Equipment Rules of Sailing

H.4.6 & H.4.7 Mast tip weight & Centre of Gravity

A submission from the Equipment Committee, Classes Committee and 420 Class

(q) MAST TIP WEIGHT

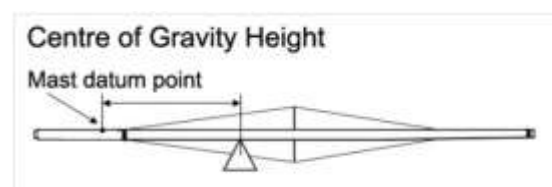
H.4.6 Mast tip weight shall be checked with any **halyards** fully hoisted and with tails on the lower limit mark and **rigging pulled taut and tied to the spar at the lower limit mark.**
~~with lower ends hanging free or resting on the ground.~~

H.4.7 Mast centre of gravity height shall be checked with any **halyards** fully hoisted and with tails on the lower limit mark and **rigging pulled taut and tied to the spar as close to at the lower limit mark. point as possible.**
~~point as possible.~~

Diagrams in F.2.3 (q) and (r) to be modified accordingly as follows:
